**BELL BEND NUCLEAR POWER PLANT  
BBNPP PLOT PLAN CHANGE COLA  
SUPPLEMENT, PART 3 (ER); SECTION 2.1  
AND PARTIAL RESPONSE TO STO 2.1-1  
BNP-2010-227                      Docket No. 52-039**

Enclosure 1 provides the revised BBNPP COLA Supplement, Part 3 (Environmental Report), Section 2.1, Revision 2a. The revised BBNPP COLA section supersedes previously submitted information in its entirety. No departures and/or exemptions to this BBNPP COLA section have been revised as a result of the PPC.

Revised BBNPP COLA Part 3 (ER), Chapter 2.1, Revision 2a

Updated Responses to RAI STO 2.1-2 and RAI TE 2.4-1  
for COLA Part 3 (ER), Chapter 2.1

Figure 2.1-1—BBNPP Site and Proposed New Plant Layout

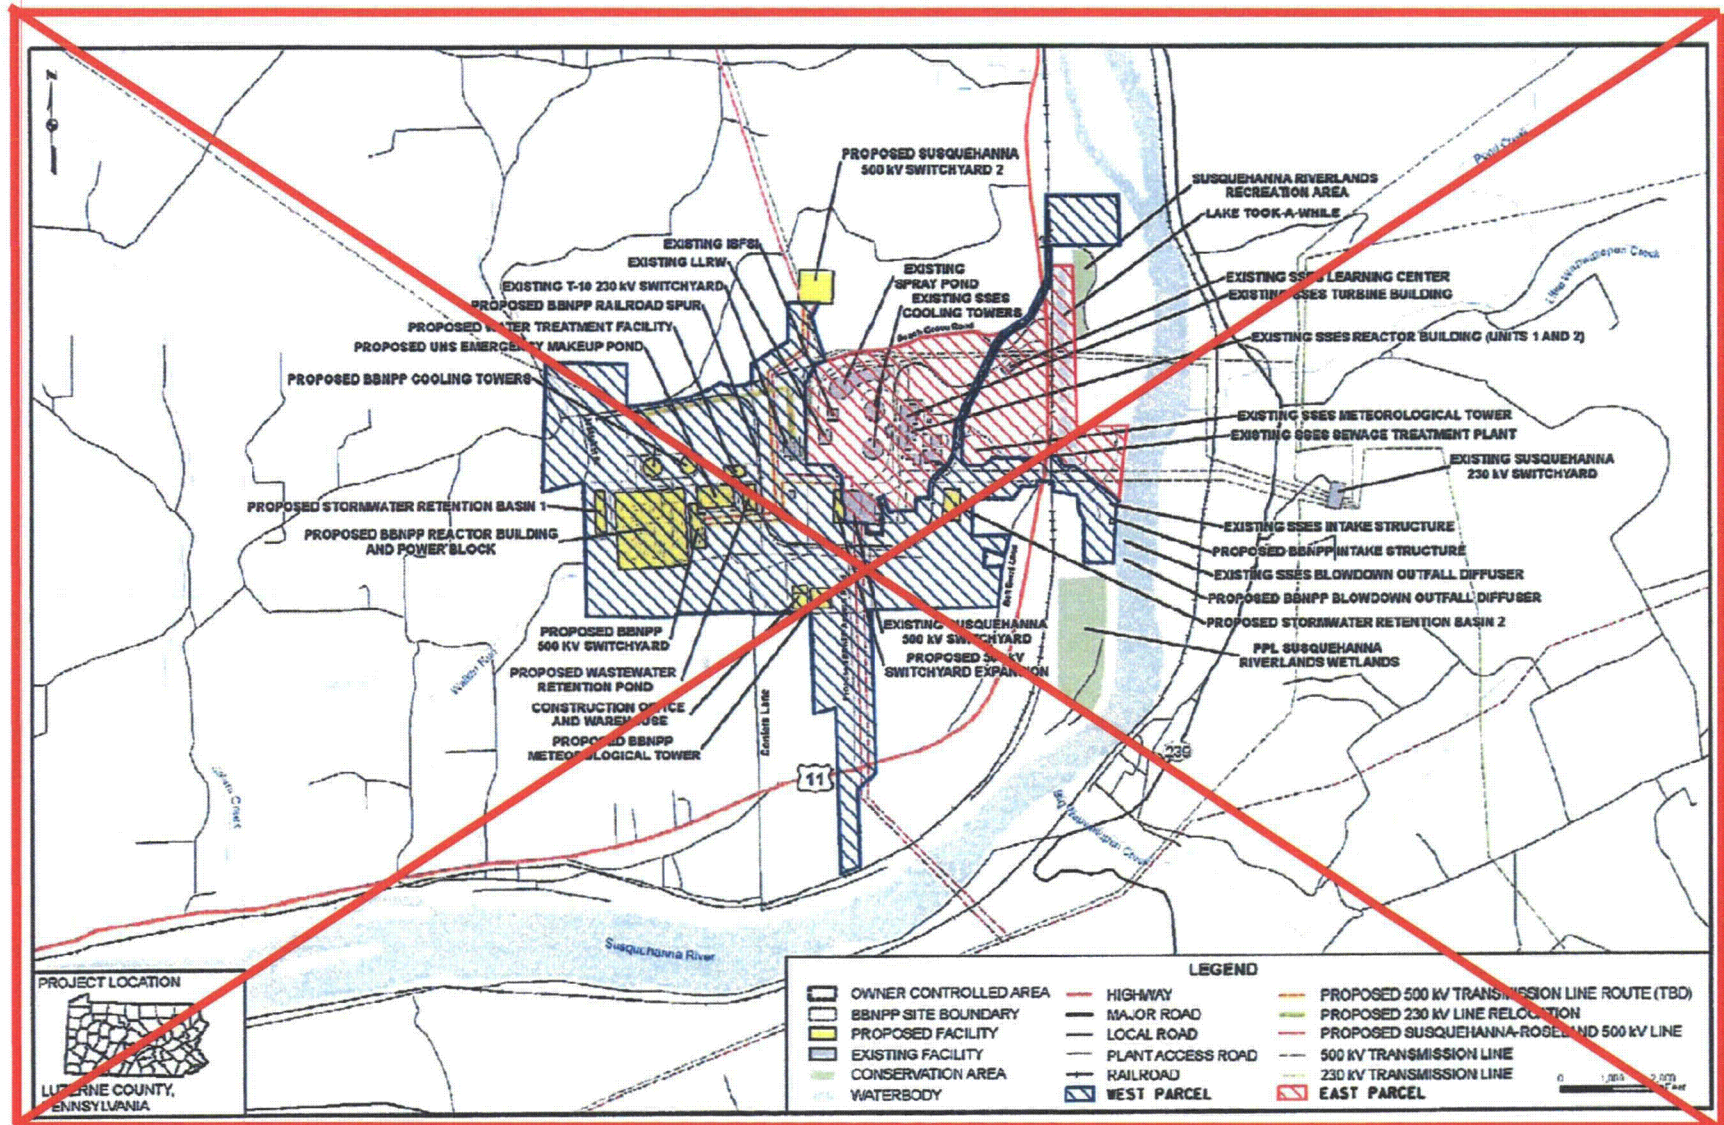
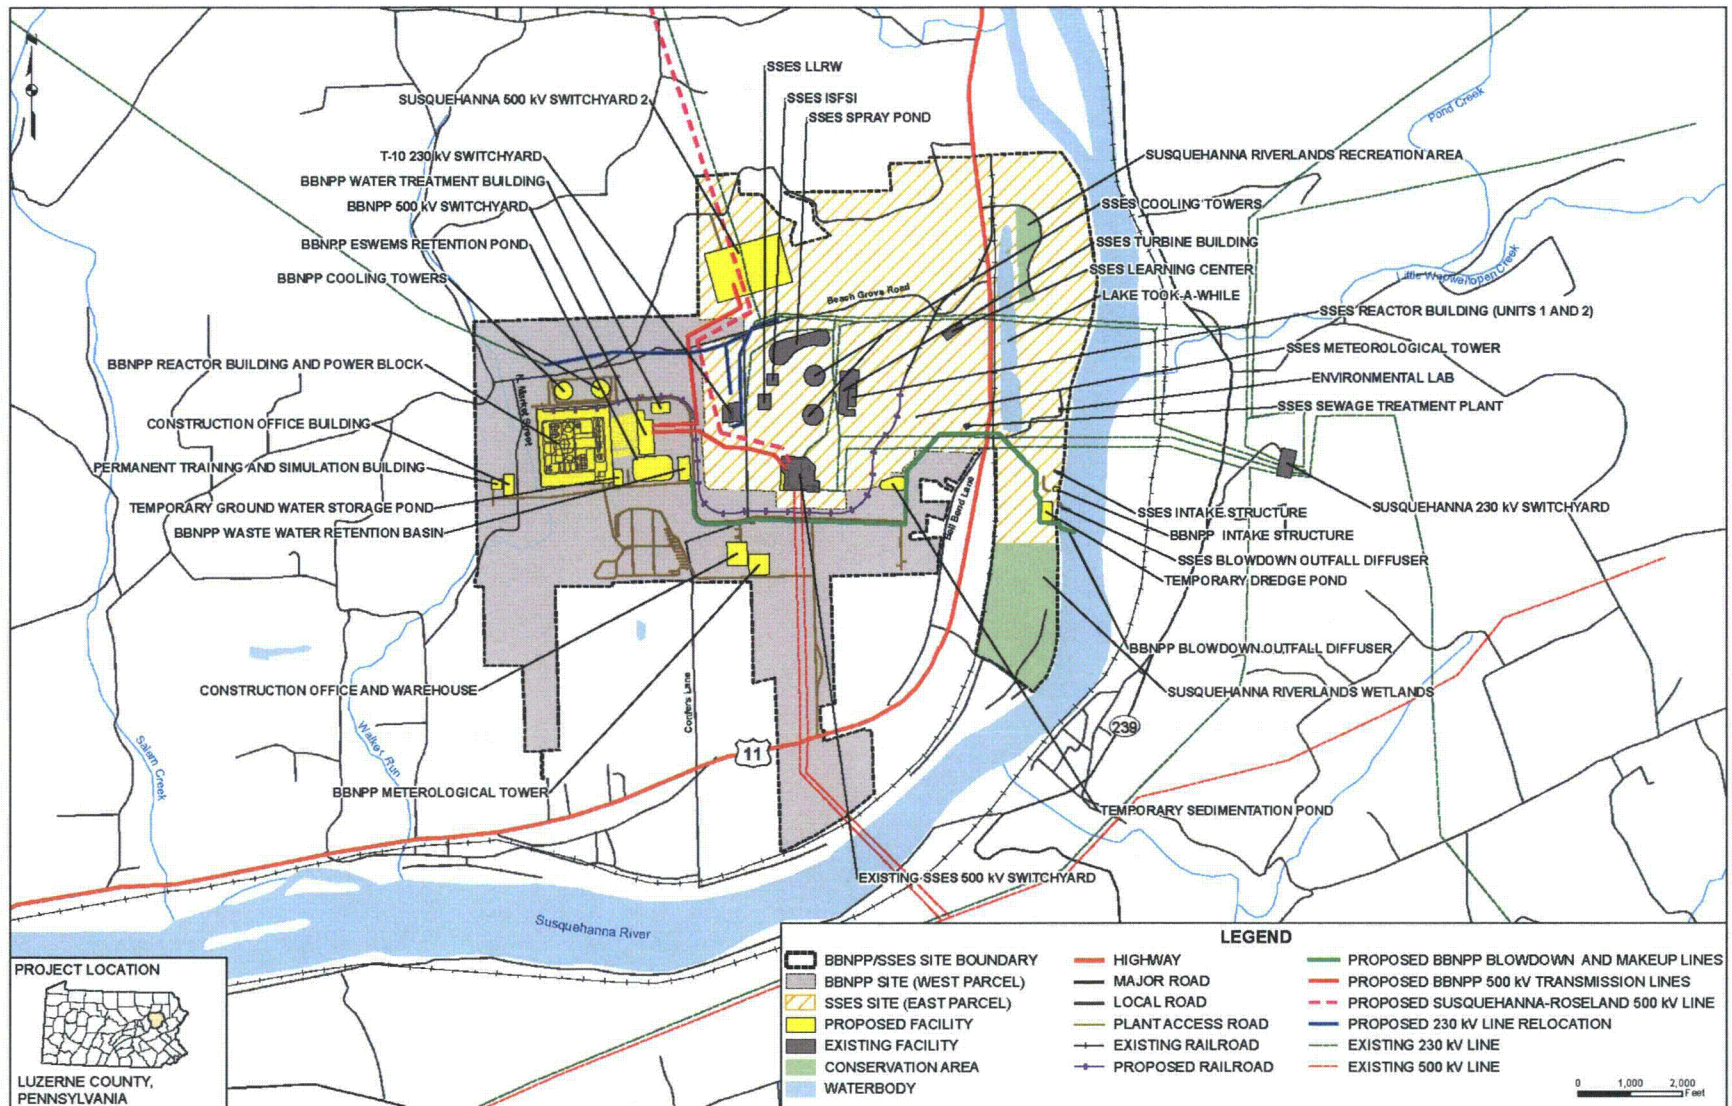
**Summary:** *Provide a revised site map clearly showing the boundaries of the east and west parcels referred to on Page 2-6 or the ER.*

A revision to Figure 2.1-1 "BBNPP Site and Proposed New Plant Layout" is attached. The revised figure identifies the areas referred to as the East Parcel and the West Parcel.

BBNPP COLA ER Figure 2.1-1 will be revised, as follows:

Figure 2.1-5—Area Uses During Construction

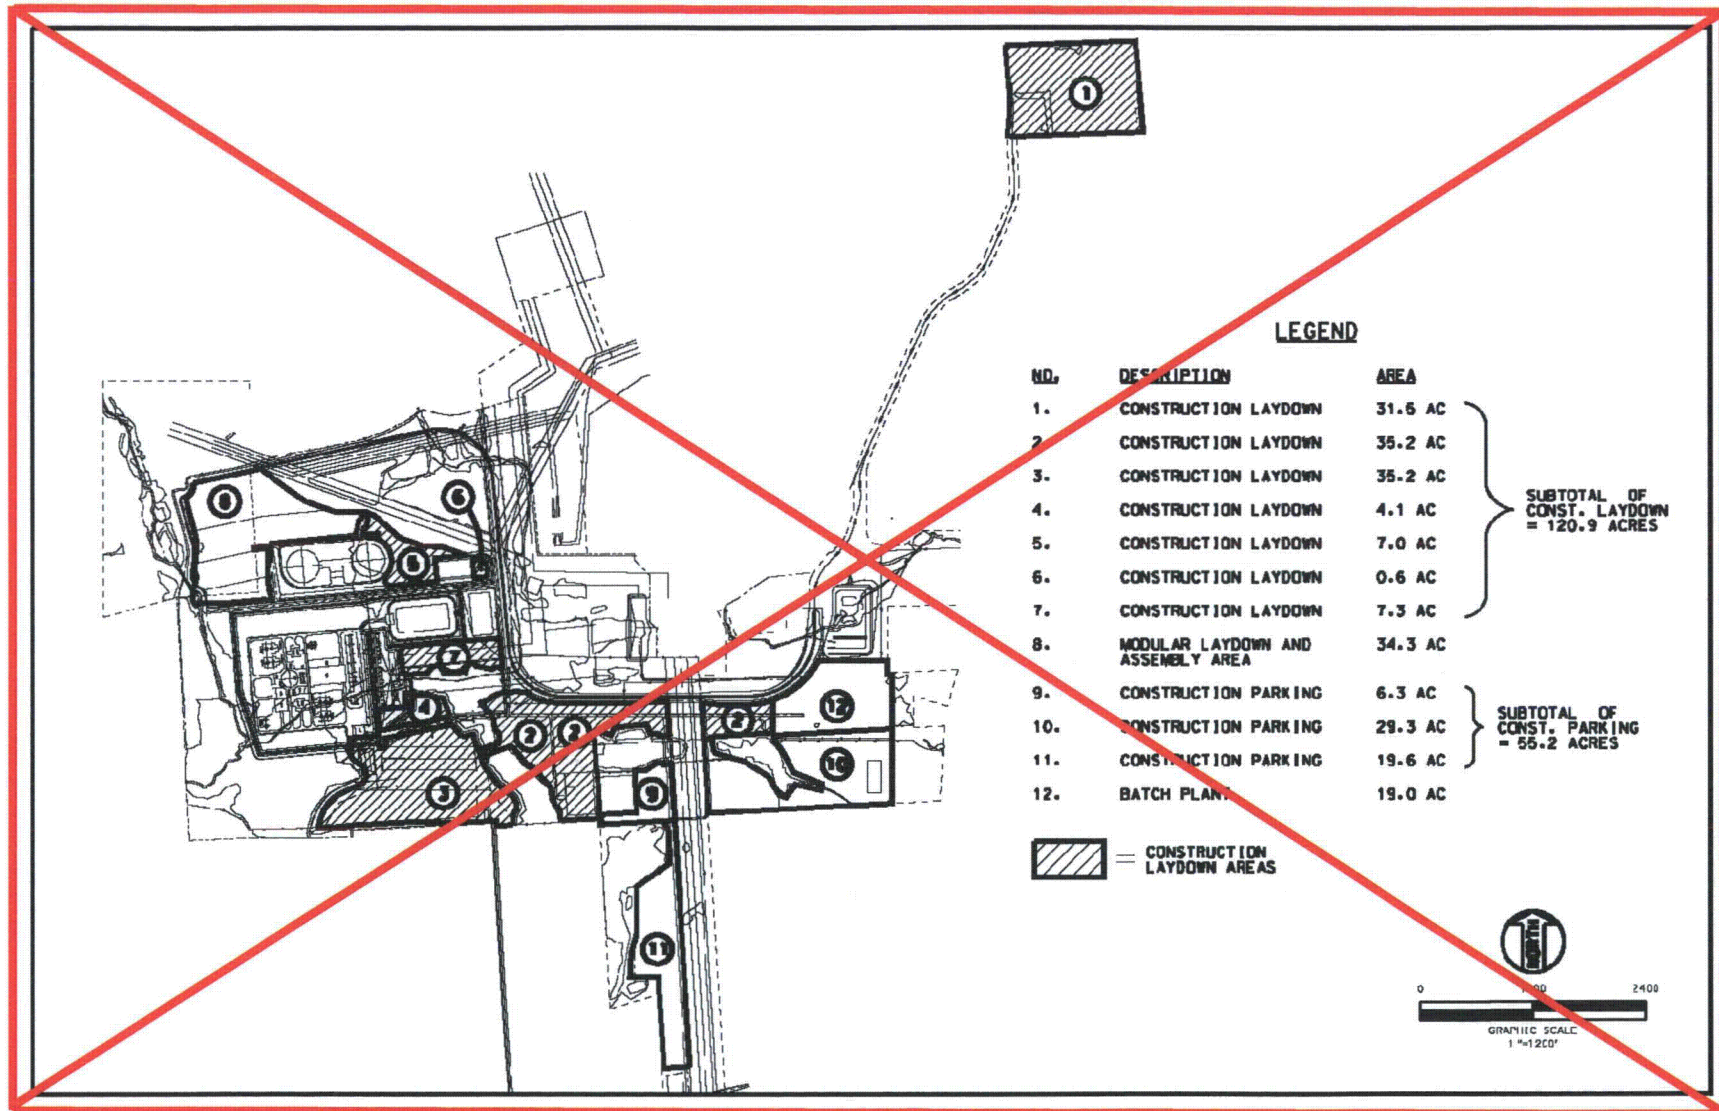
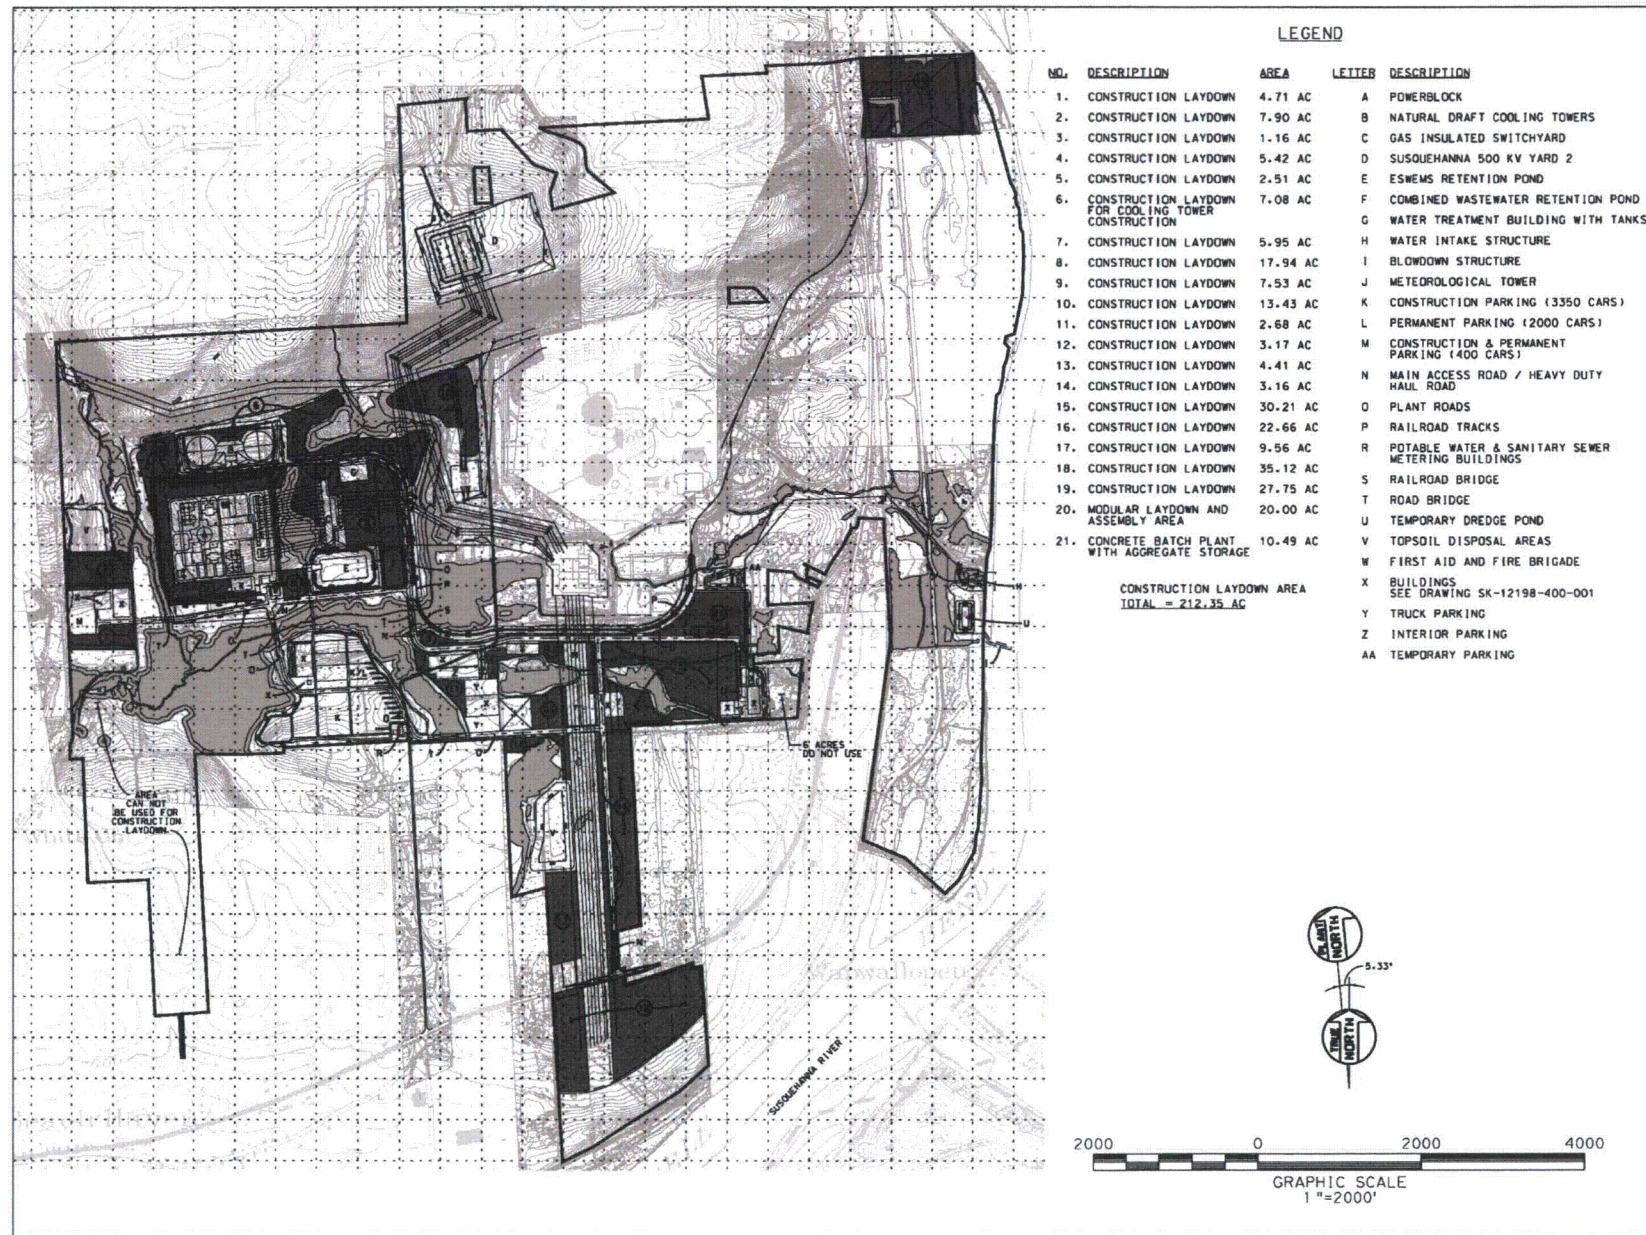
**Summary:** *Identify the location of all lay-down areas in Figure 2.1-1, BBNPP Site and Proposed New Plant Layout, or provide a new figure to show the location of these features.*

A new Figure 2.1-5, "Area Uses During Construction" was prepared to answer this question as a result of the plot plan change.

BBNPP COLA ER Figure 2.1-5 will be revised, as follows:
